BOARD ACTION REPORT – APPEALABLE ITEM

Project Name:	132 N Swinton Avenue
Project Location:	132 N Swinton Avenue
Request:	Certificate of Appropriateness (COA) and Class II Site Plan
Board:	Historic Preservation Board
Meeting Date:	May 1, 2019

STAFF REPORT

ITEM: 132 N Swinton Avenue, Old School Square Historic District – Certificate of Appropriateness (2019-136) and Class II Site Plan Application for exterior modifications to the existing structure and modification of the existing landscaping.

LANDSCAPE PLAN

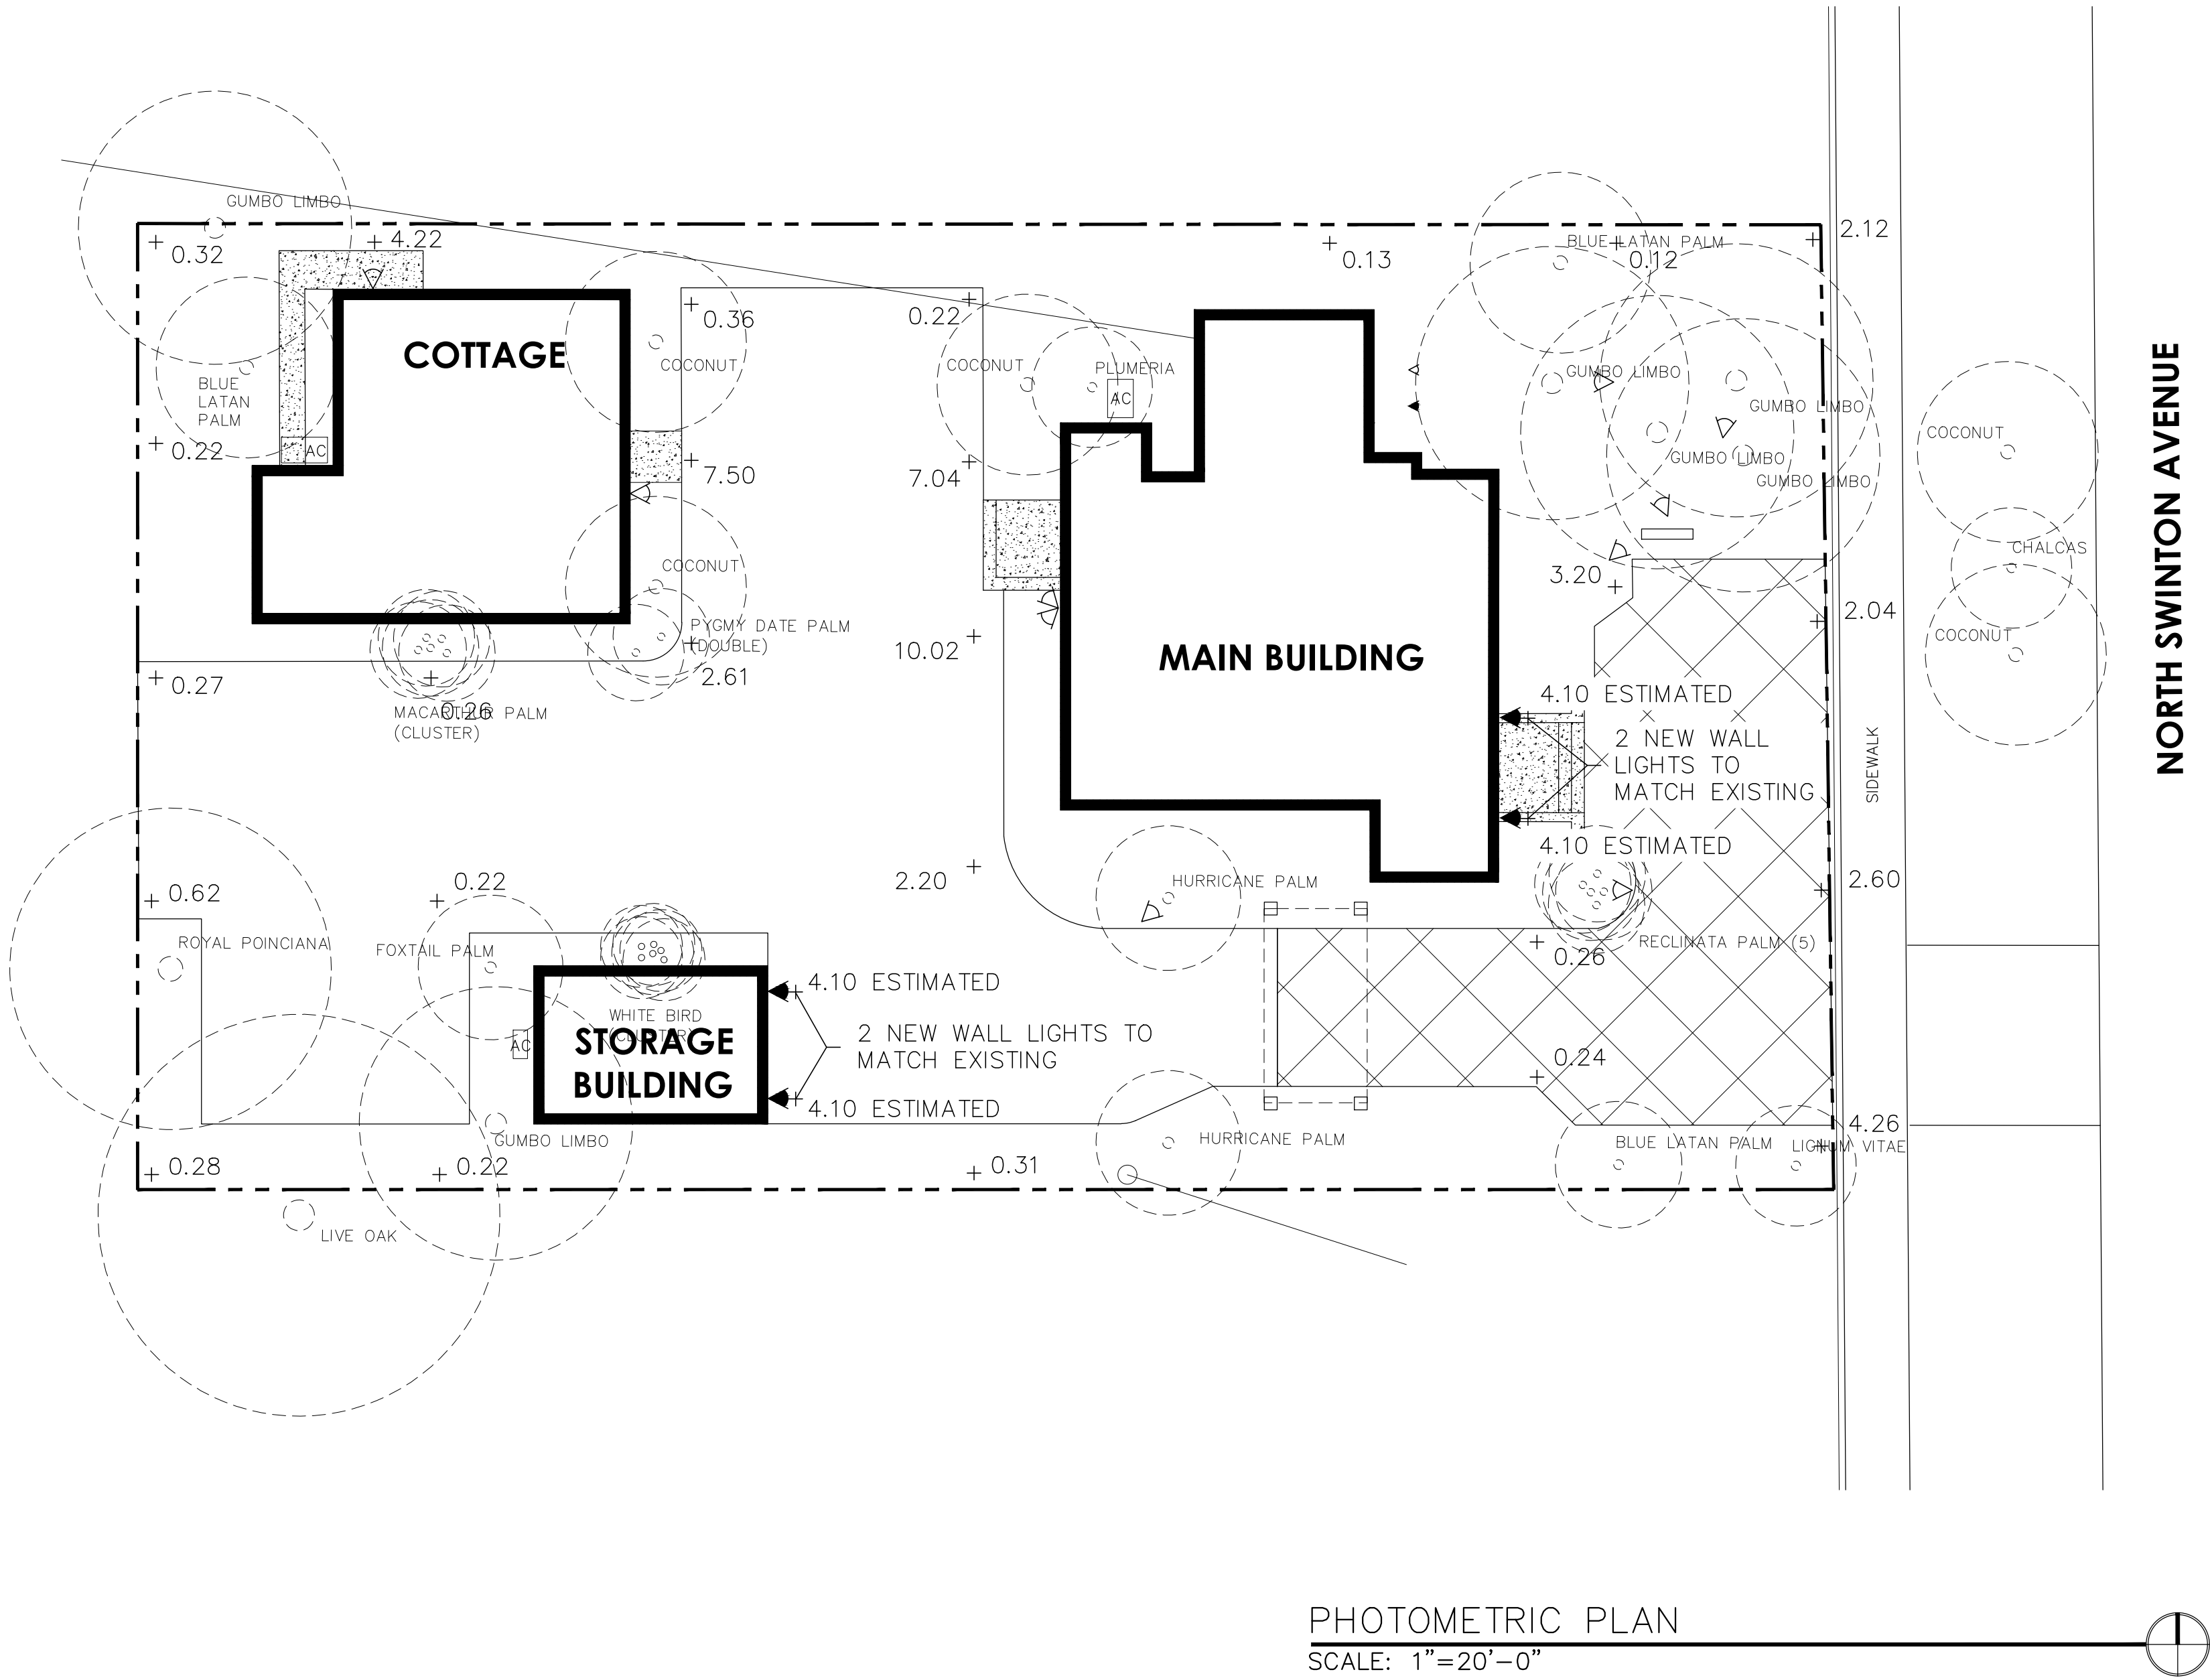
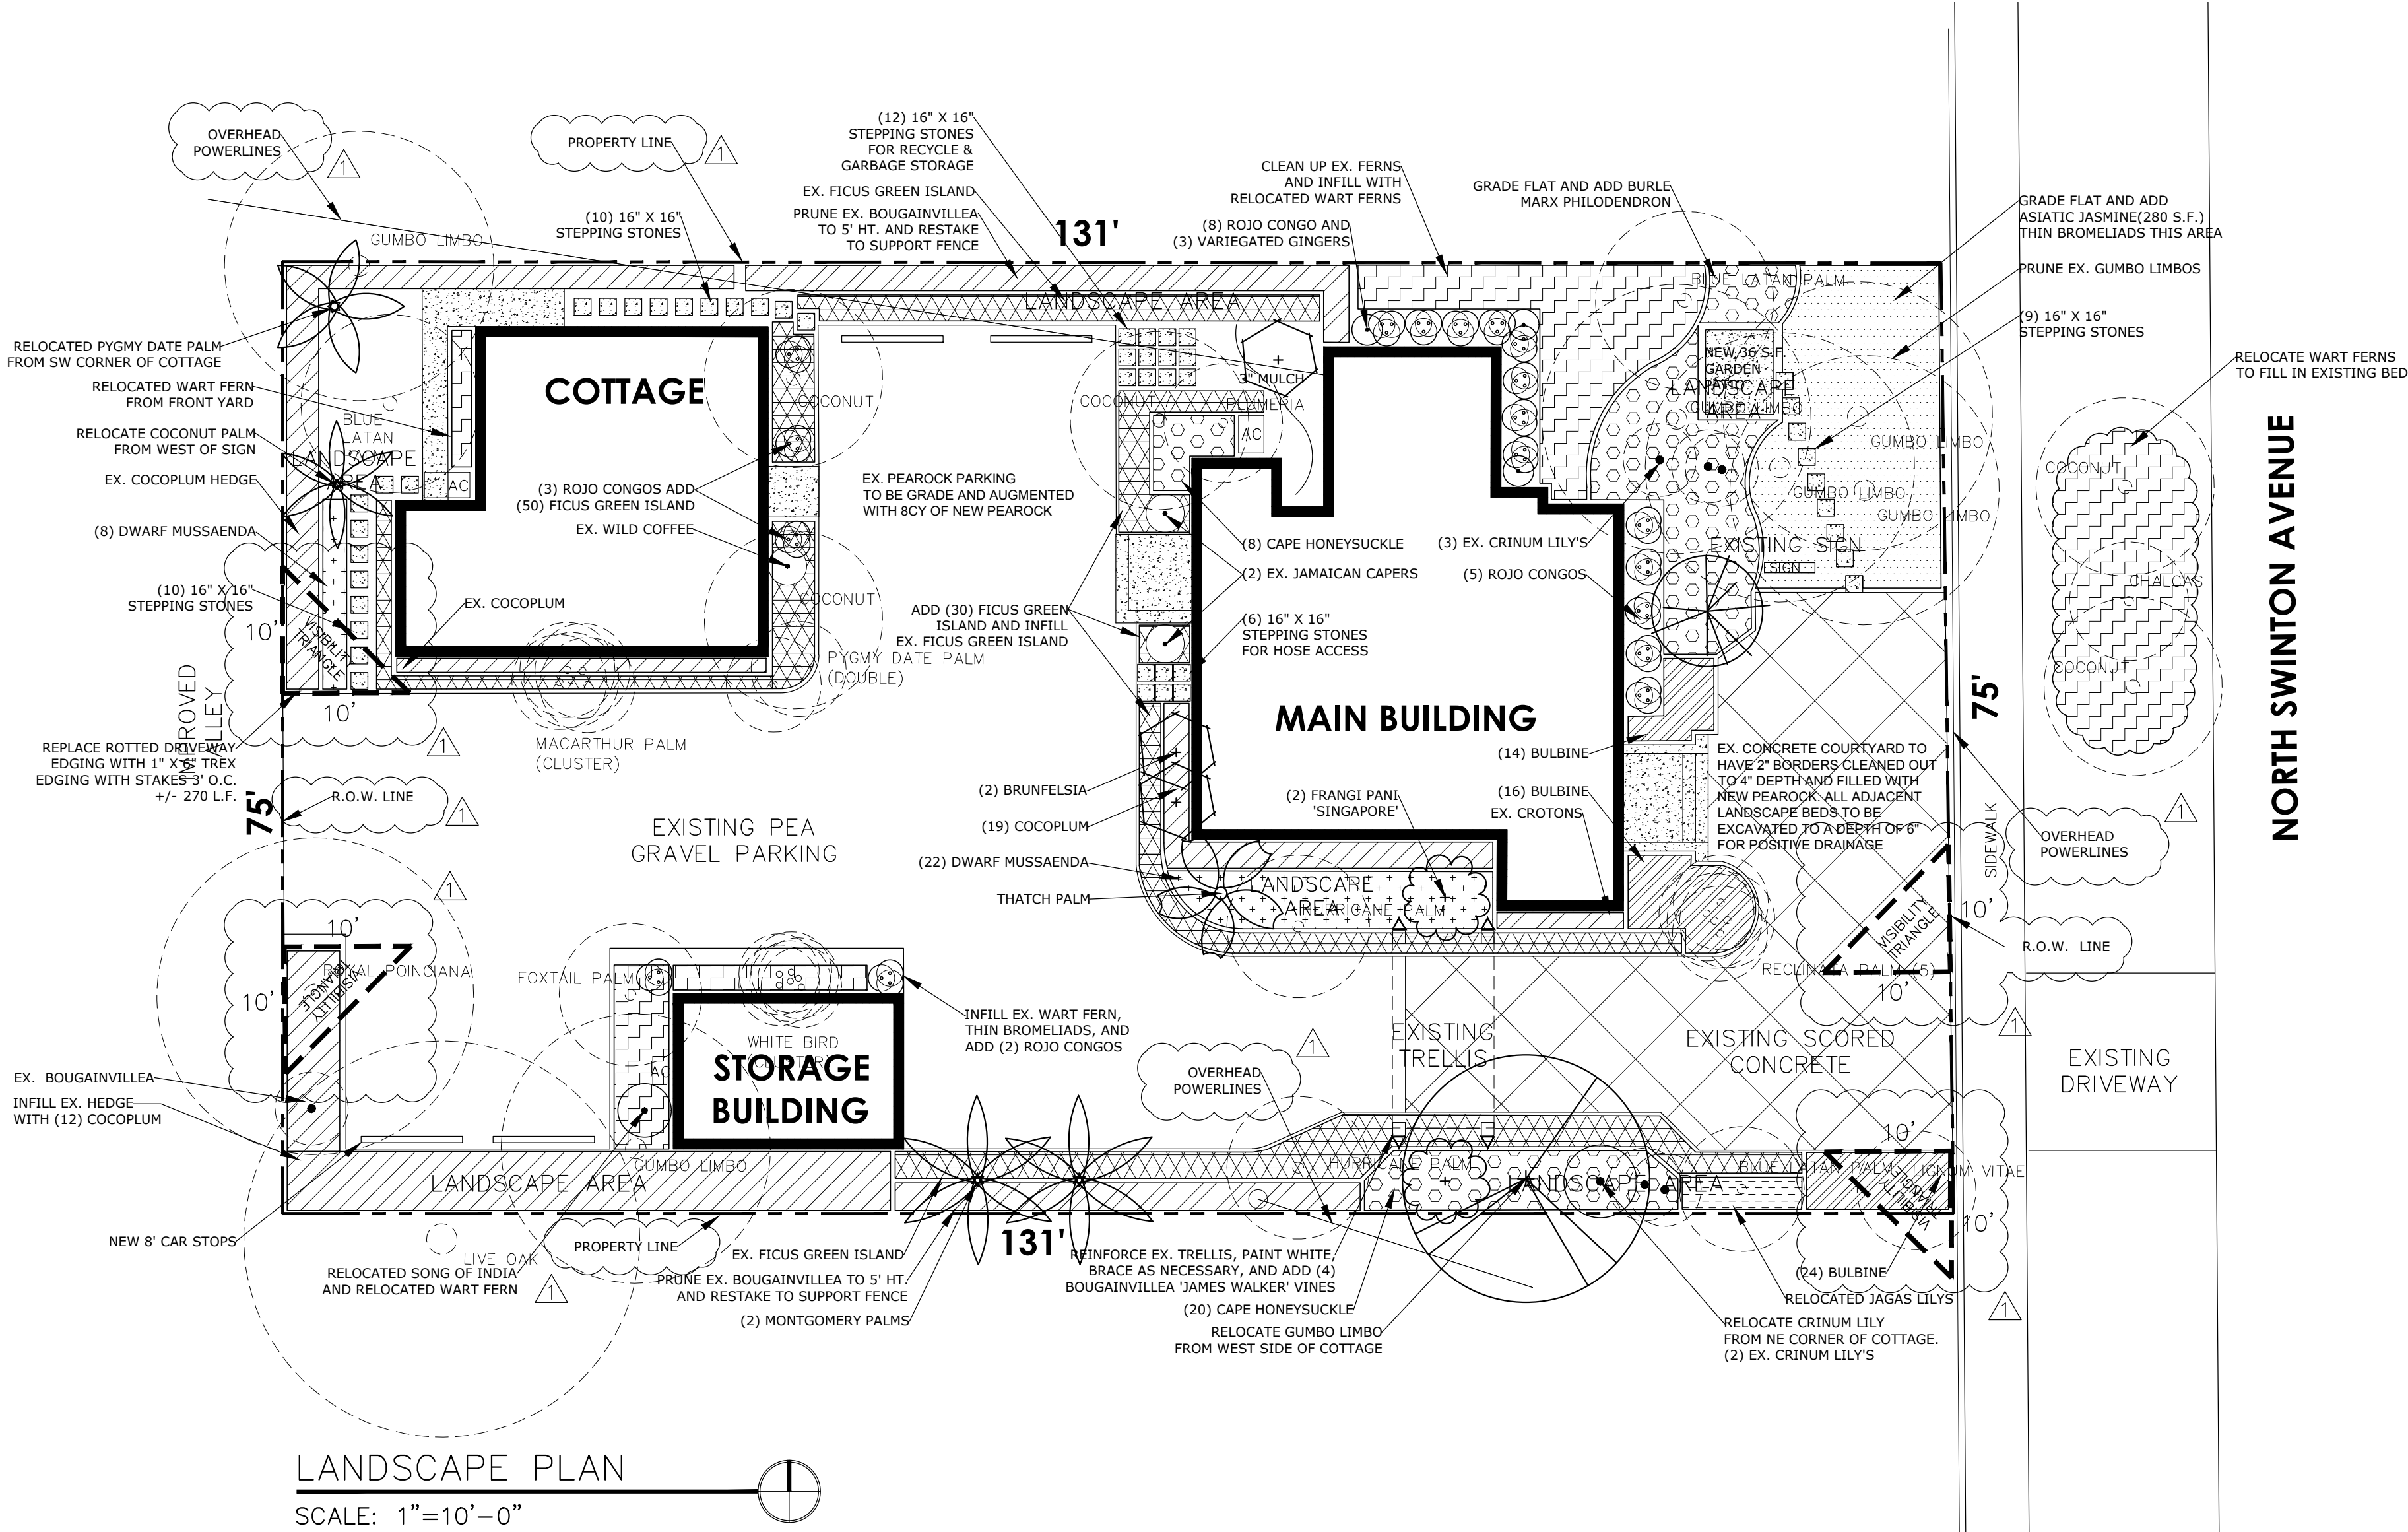
The proposal has been reviewed and determined to be in compliance with LDR Section 4.6.16. The landscape plan includes replacement of existing landscape material as well as installation of new landscaping to meet the requirements of the code; therefore, positive findings with this code section are made.

PHOTOMETRIC PLAN

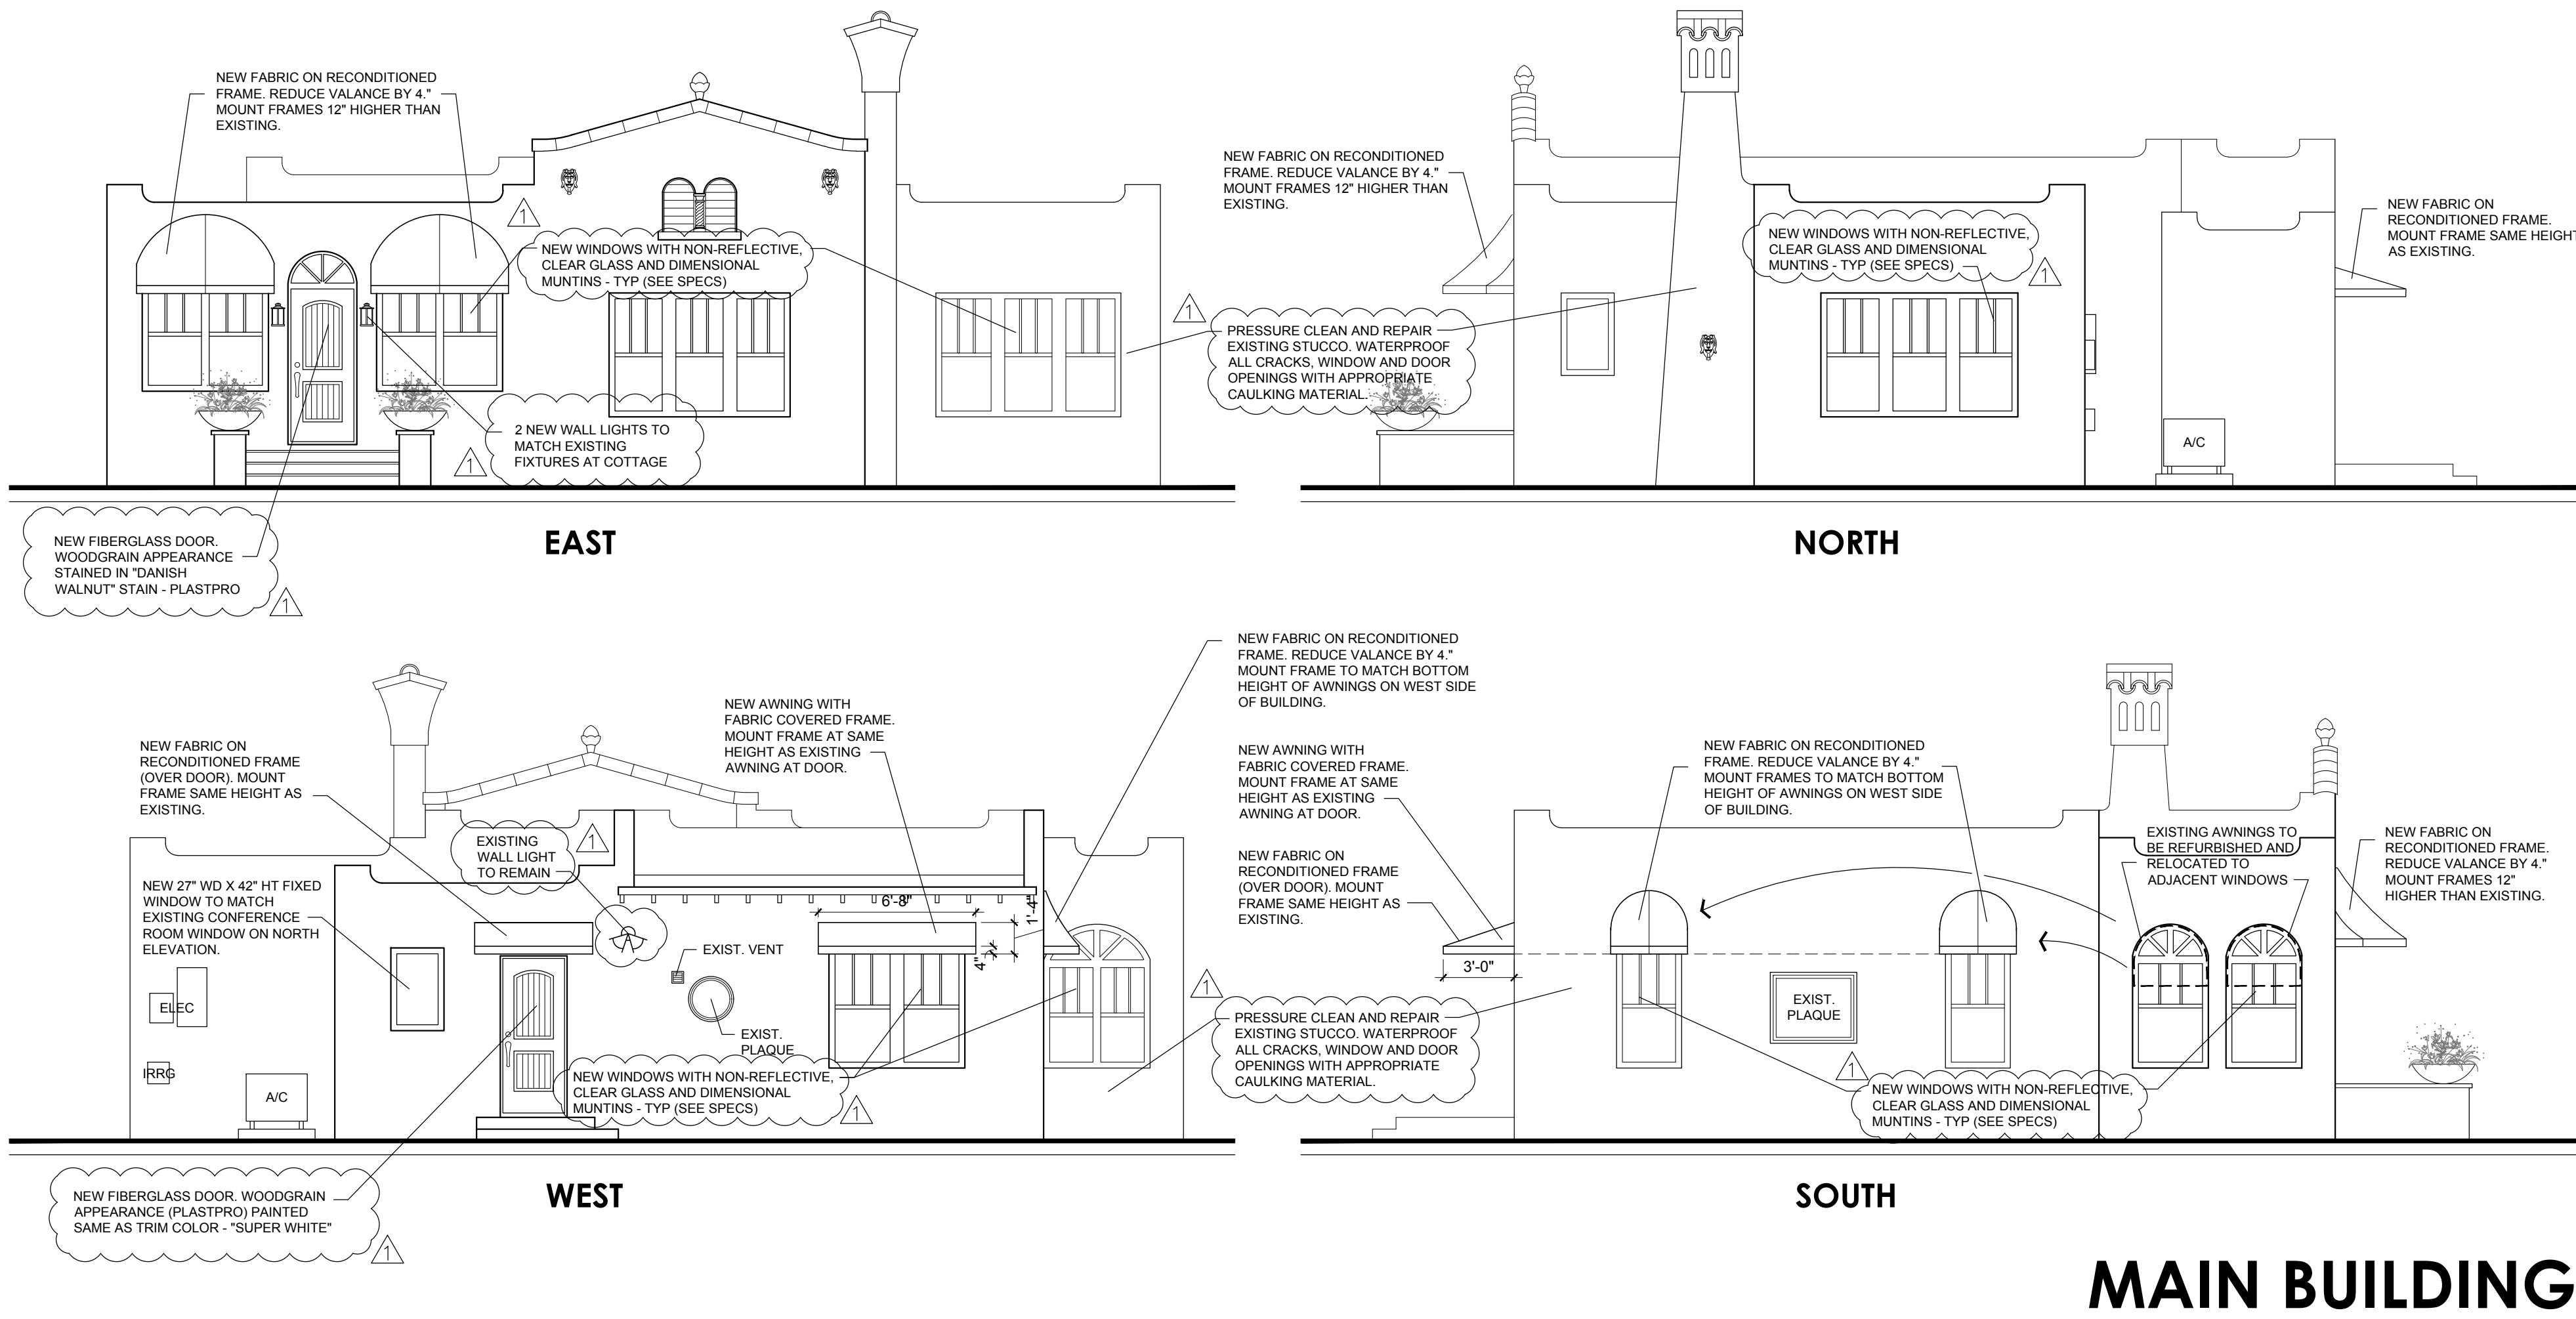
The proposal includes the installation of 4 new wall mounted decorative light fixtures on the office structures adjacent to the existing parking areas on the east side of each structure. The fixtures are residential in nature and are appropriate for the surrounding historic area. The submitted photometric

plan illustrates that the proposed light fixtures will meet the maximum permitted foot-candles. An added condition of approval is that the foot-candles for the 2 fixtures on the main building be reduced to minimize spillover onto adjacent properties to no more than 0.25. Provided the condition of approval is addressed, the photometric plan will be in compliance with the Illumination Standards listed above, and within an appropriate foot candle range given the surrounding mixed-use area.

1. That the foot-candles for the 2 light fixtures on the main building be reduced to minimize spillover onto adjacent properties to no more than 0.25;
2. That the existing rough stucco texture be preserved; and,
3. That staff have the authority to approve the color of the awnings to “champagne”.
